UNITED STATES PATENT AND TRADEMARK OFFICE

APPLICATION NO.	FILING DATE	FIRST NAMED INVENTOR	ATTORNEY DOCKET NO.	CONFIRMATION NO.
10/821,890	04/12/2004	Young-Lae Kim	SEC.1145	2497

Office Action Summary

DETAILED ACTION

FIG. 1 (PRIOR ART)

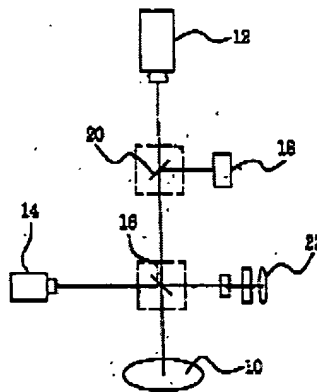
Considering **claim 1**, the Admitted Prior Art, as mentioned in Figure 1 and the detailed description of the instant application discloses an alignment measuring system, comprising:

- a. a focusing diode (18);
- b. a light source (14);
- c. a first splitter (16), adapted to direct a first part of the light emitted from the light source toward the wafer on the stage (10) ...the wafer receives the light...and reflects and/or diffracts at least a portion of that light back toward the first splitter (Paragraph 15);

- d. a second splitter (20), adapted to direct a first portion of the reflected/diffracted light from the wafer (10)...toward the focusing diode (Paragraph 15);

- e. an image sensor (12) adapted to receive a portion of the reflected/diffracted light from the second splitter (20) (Paragraph 15);
- f. a controller adapted to receive the information provided through the reference mirror, focusing diode, and image sensor to detect a focus for a positional state of the wafer (Paragraph 16)...to control the stage (10) on which a wafer is positioned in response to a control signal of a controller (Paragraph 13).

The Admitted Prior Art fails to disclose a controller adapted to receive the detection signal from the second splitter and to vary the respective power levels of the first and second portions of light.

Regarding **claim 4**, and as applied to **claim 1 above**, the Admitted Prior Art discloses a “second part of the light” along side the first splitter (see Figure 1 of the Admitted Prior Art) “emitted from the light source toward a reference mirror” (Paragraph 15).

Considering **claim 11**, the Admitted Prior Art, as mentioned in Figure 1 and the detailed description of the instant application discloses a method for determining an alignment position of a wafer, comprising:

- b. providing light reflected from the reference mirror to the focusing diode (Figure 1).
